COUNCIL WORKSHOP AGENDA

Memo Date: April 14, 2023
Meeting Date: April 20, 2023
To: Newport City Council
From: Nathan Fuerst, AICP, City Planner
Subject: Concept Plan Review – Red Rock Villas

Action Requested: Review the Concept Plan and provide comments relating to the conformance of the plan with adopted plans and policies.

1 Site
A101 SC. 1" = 50'-0"

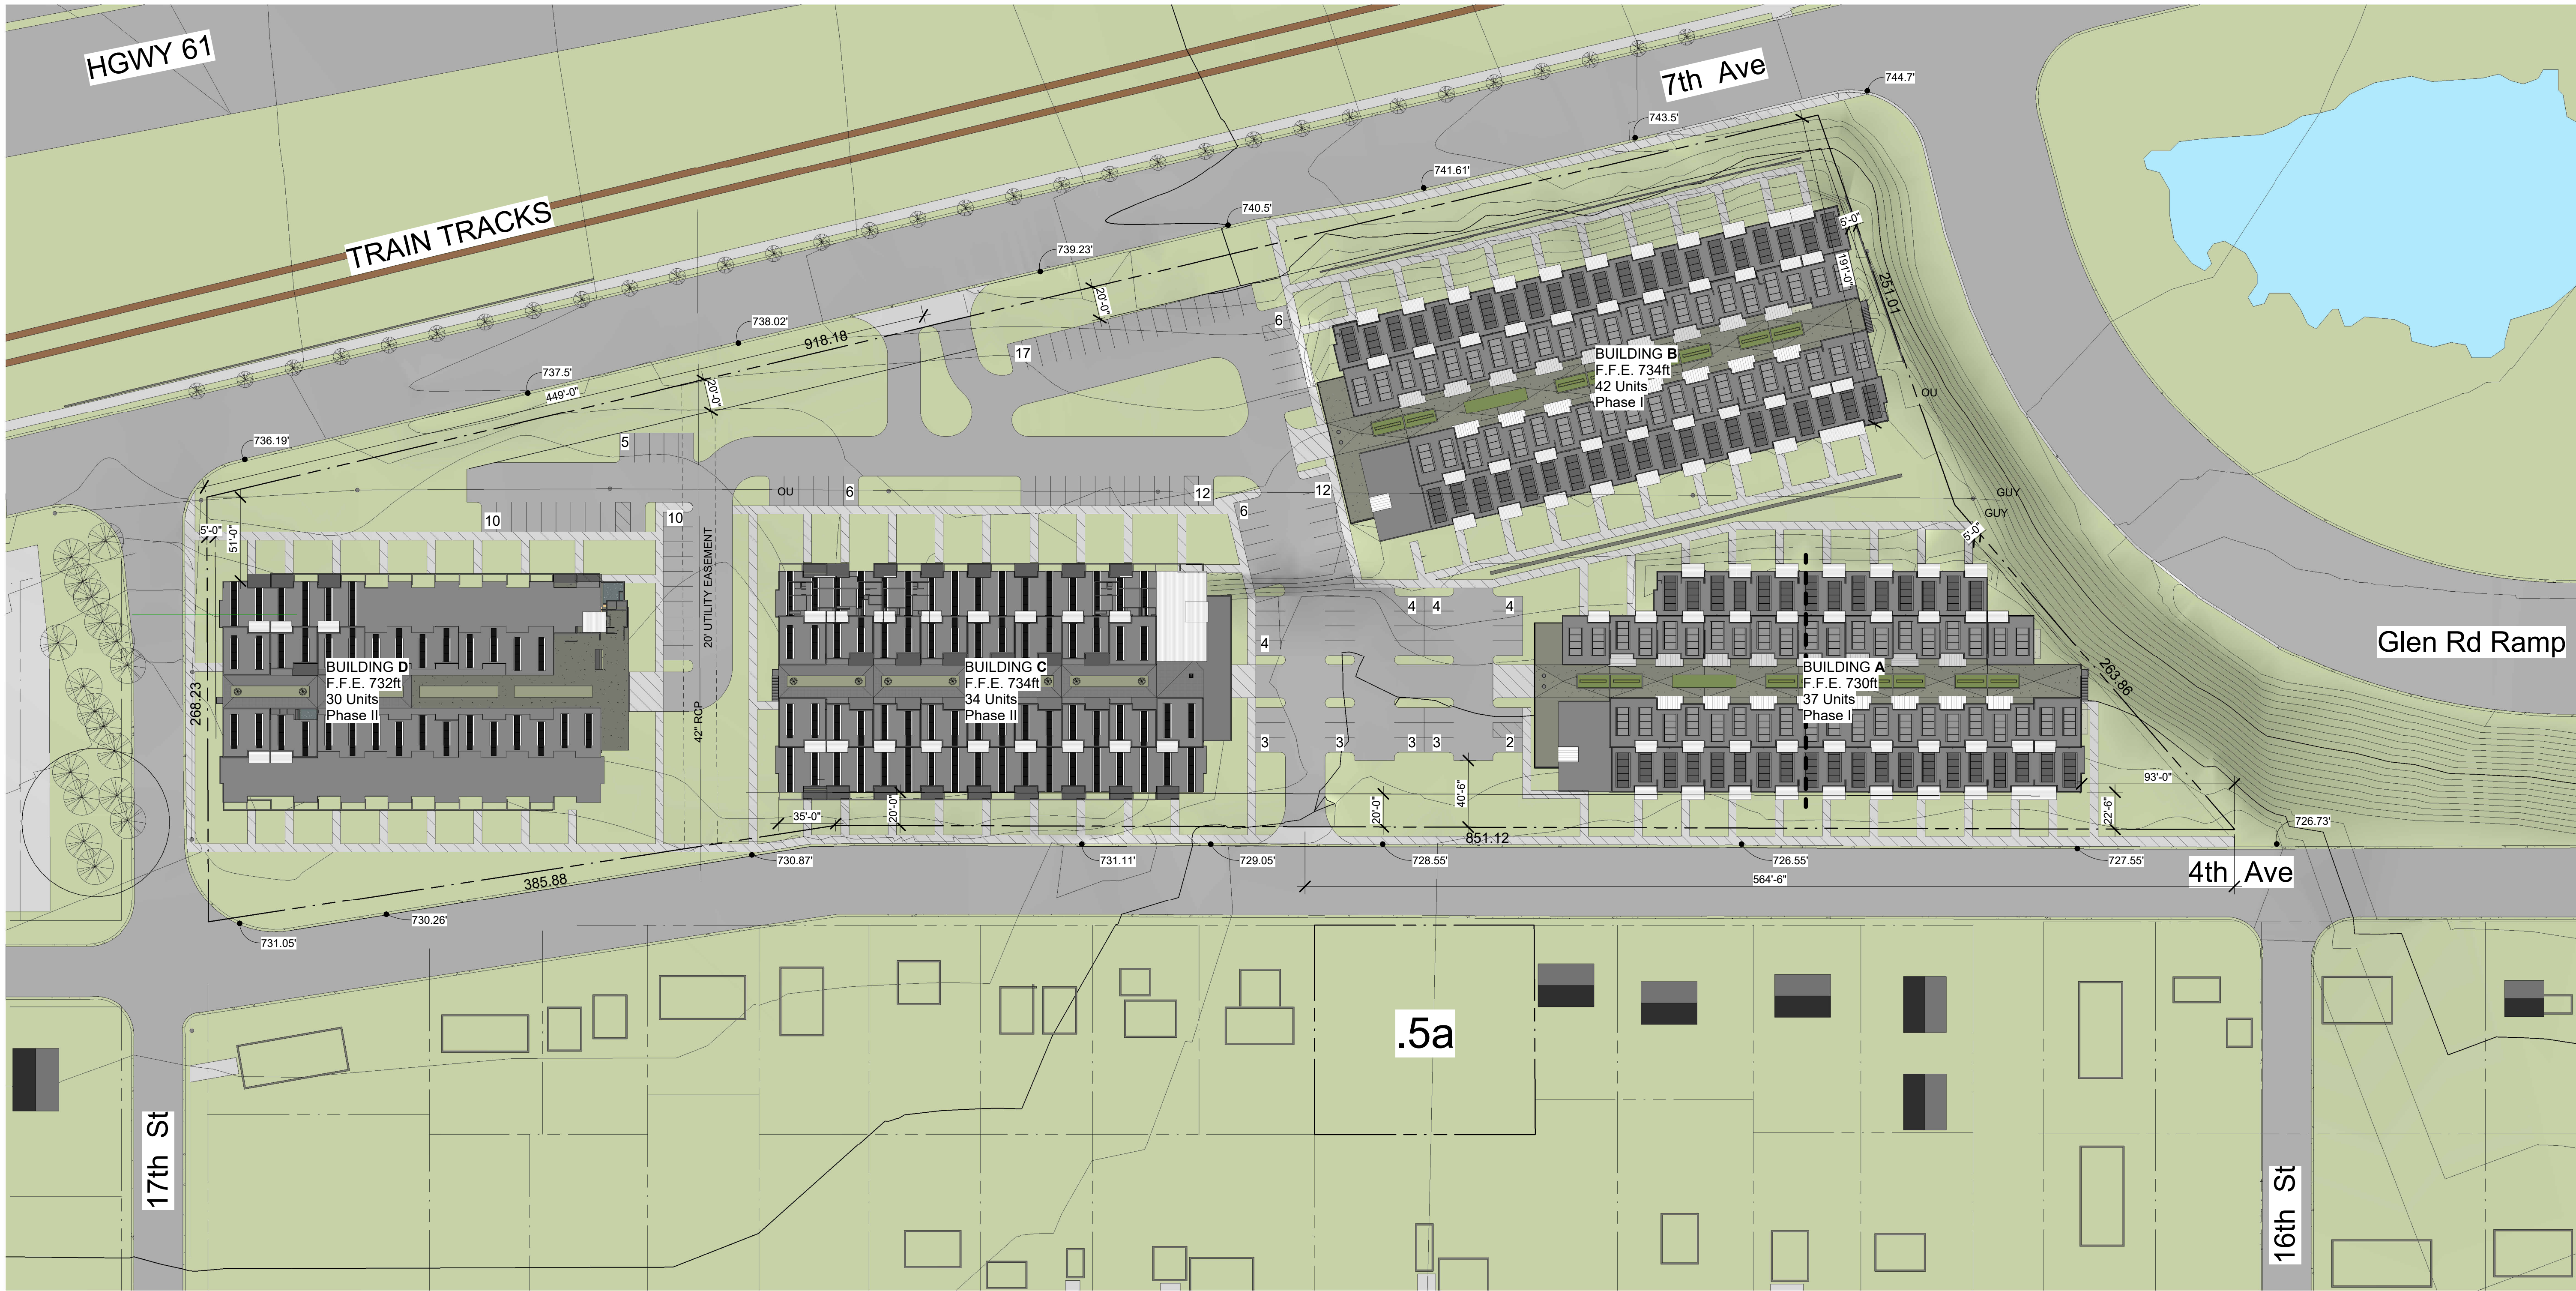
As proposed, the concept plan shows all four structures on one lot. It is understood that the developer would prefer to keep all structures on the same lot. Staff note that this would require a PUD deviation to City Code Section 36-11 which limits each one lot to having only one principal structure. Staff are not opposed to this request given the fact that this would be a master planned development consisting of rental units.

Staff note that the placement of several of the buildings, Building B & Building D provides for inefficient use of the site. Both of those buildings should be moved closer to 7th avenue to provide more space to the interior of this site and 4th Avenue for the purposes of stormwater management, open space, or parking area. Moving those buildings closer to 7th avenue will provide for a more engaging pedestrian environment, keeping in line with the intent of the MX-3 zoning district and establishing the standard for

Staff note an inconsistent, and in areas, inefficient use of sidewalks within this development. While internal pedestrian circulation is mostly accounted for, no sidewalks are provided for the circulation of people walking around this proposed development. Staff will strongly recommend that the City require public sidewalks around the site along 7th Avenue, 17th Street, and 4th Avenue.

Staff note that no stormwater facilities are provided on site or mentioned in the submittal. Inclusion of ponds to meet required stormwater management rules has the potential to significantly alter the proposed site plan by impacting building location, parking and circulation, or open space. If such ponds are to be utilized for stormwater control, then they should be accounted for in the concept plan. If some other method of managing stormwater is proposed, the submittal should be supplemented or revised accordingly.

Buildings proposed on site help to screen the surface parking areas. As parking areas are not fully screened from the adjacent residential uses, additional screening should be provided. Staff suggest landscaping, potentially combined with beaming where screening is required.

Parking Screening – The City Code requires parking areas to be screened from the street and surrounding properties with residential land uses. The proposed arrangement of buildings on the lot one way to meet this requirement. Berming and landscaping is another. This should be addressed by future submittals.

Currently the Developer is compliant with the number of visitor stalls at 115 and will need a total of 328 stalls to meet the City's total minimum parking requirement. The Developer's site plan indicates two numbers for parking provided, one which is below the City's required total, and one which is above. Should the Developer ultimately need to seek flexibility to the City's ordinance, this can be done through the PUD process.

The Concept shows a consolidation of access points to this site to just one access off of 7th Avenue and one off of 4th Avenue. Further refinement of the access off of 7th Avenue will need to be explored. That access should only include one lane entering the site and one lane exiting the site.
